# ADDENDUM NO. 1

## ROCK RIVER WATER RECLAMATION DISTRICT 2017-2018 Collection System Repairs Capital Project No. 1854

**Collection System Repairs 2017-2018, CIP 1854**

**ITEMS #15 & #16**

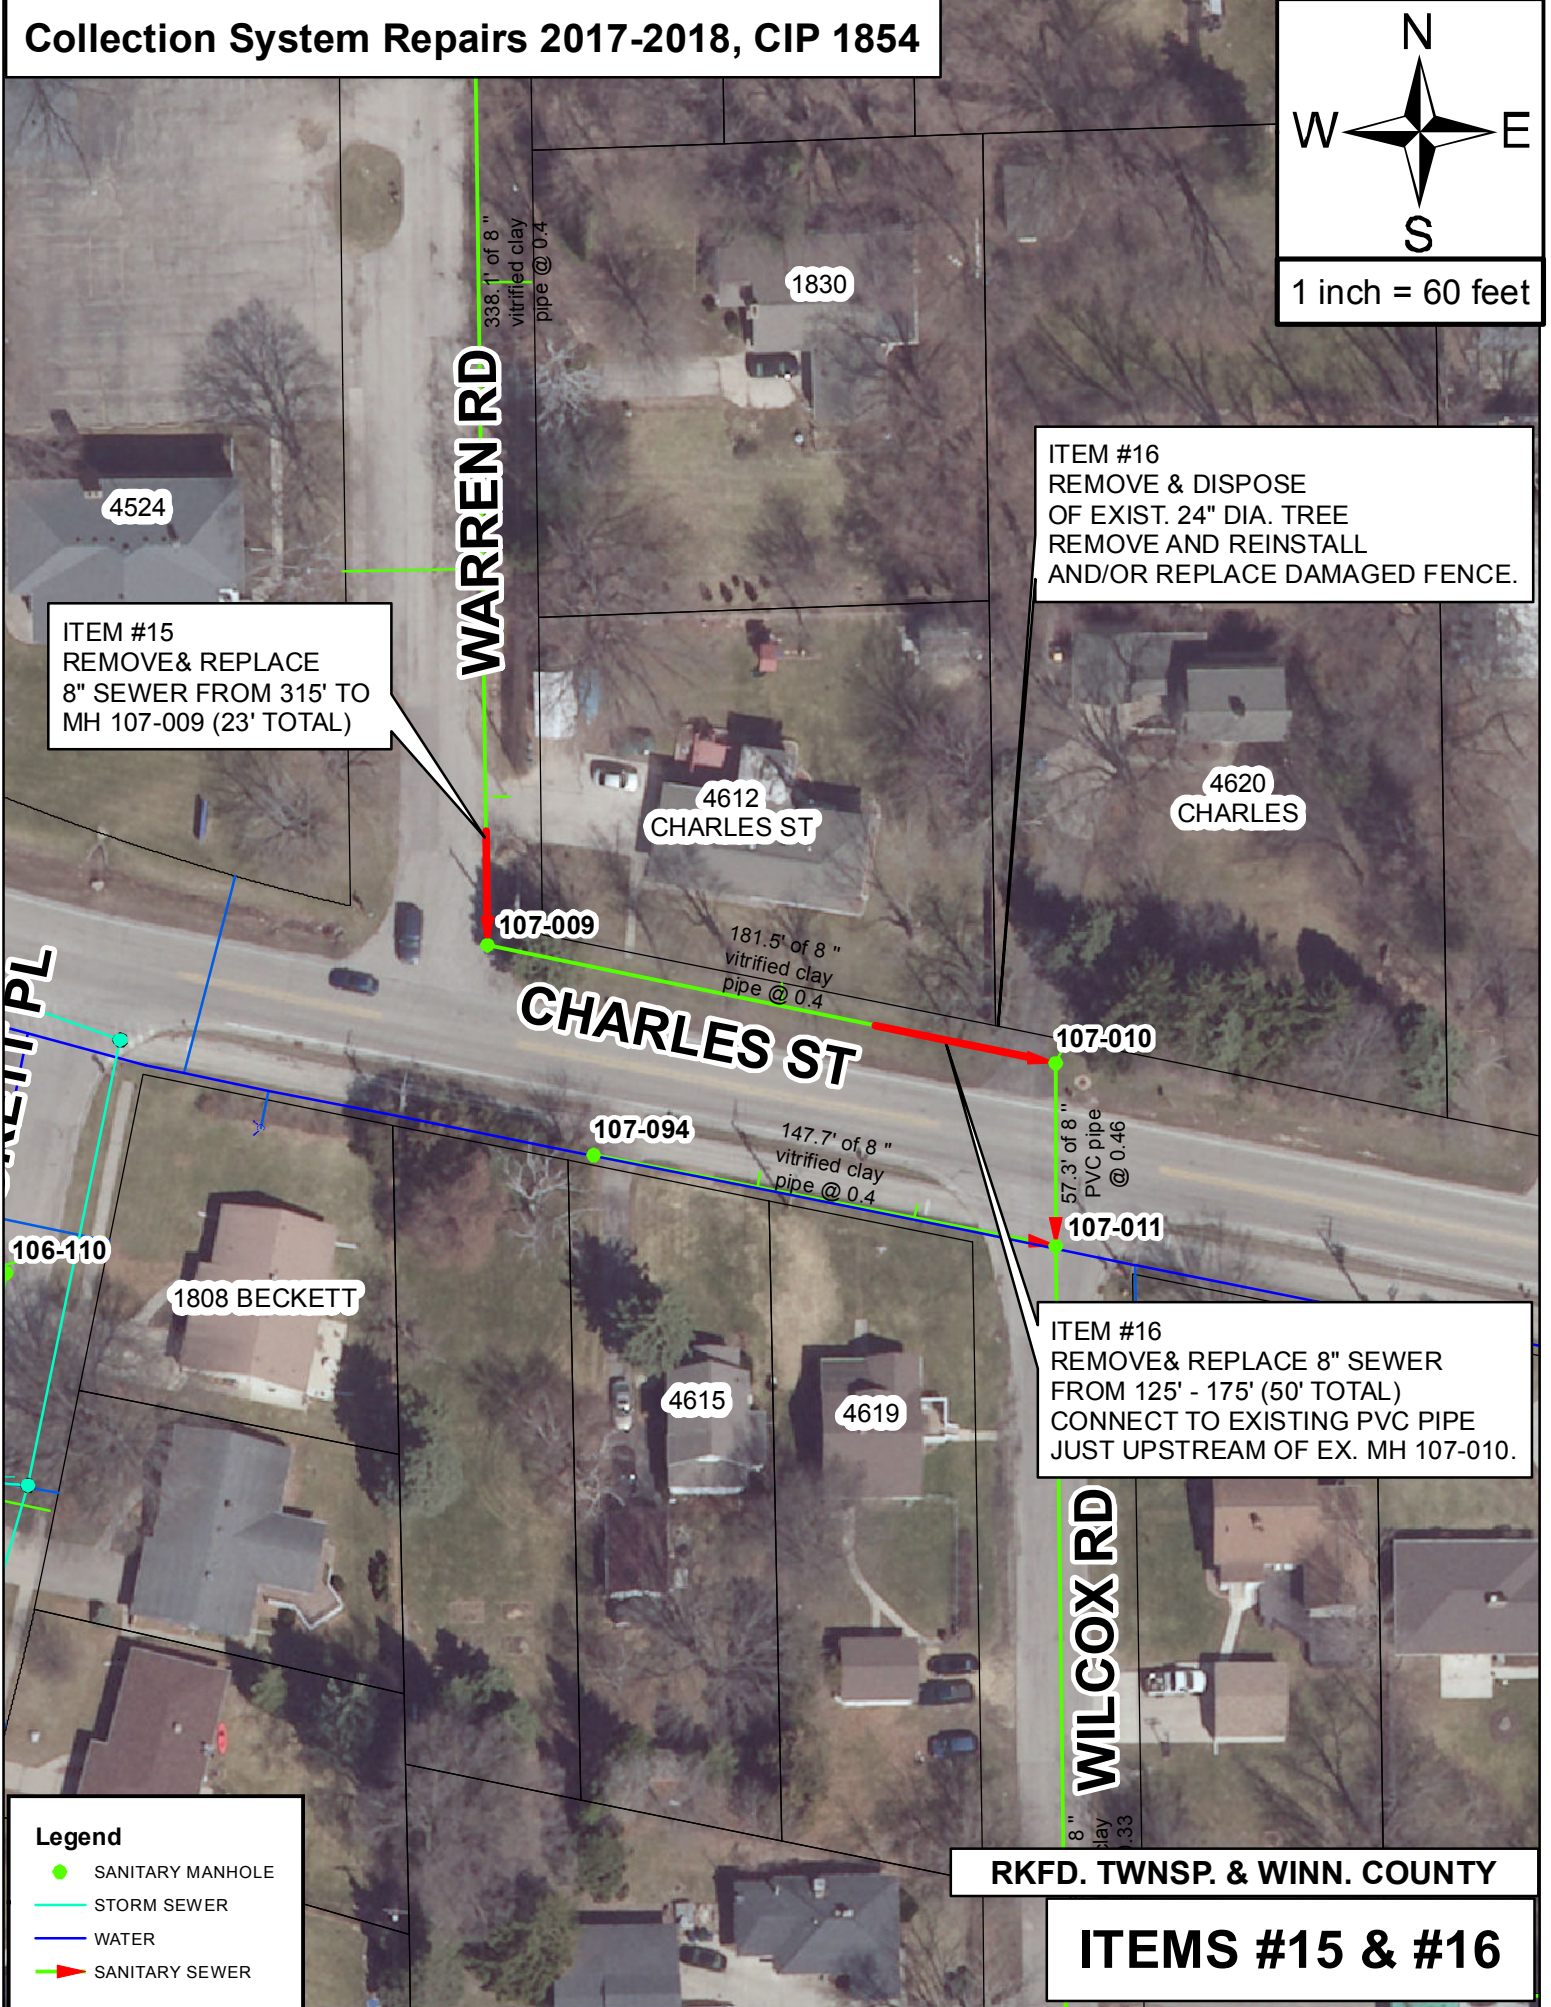
1. Replace the map for Items 15 and 16 with the attached. Labels indicating item number have been corrected.

**ITEM #15**  
 REMOVE & REPLACE  
 8" SEWER FROM 315' TO  
 MH 107-009 (23' TOTAL)

**ITEM #16**  
 REMOVE & DISPOSE  
 OF EXIST. 24" DIA. TREE  
 REMOVE AND REINSTALL  
 AND/OR REPLACE DAMAGED FENCE.

**ITEM #16**  
 REMOVE & REPLACE 8" SEWER  
 FROM 125' - 175' (50' TOTAL)  
 CONNECT TO EXISTING PVC PIPE  
 JUST UPSTREAM OF EX. MH 107-010.
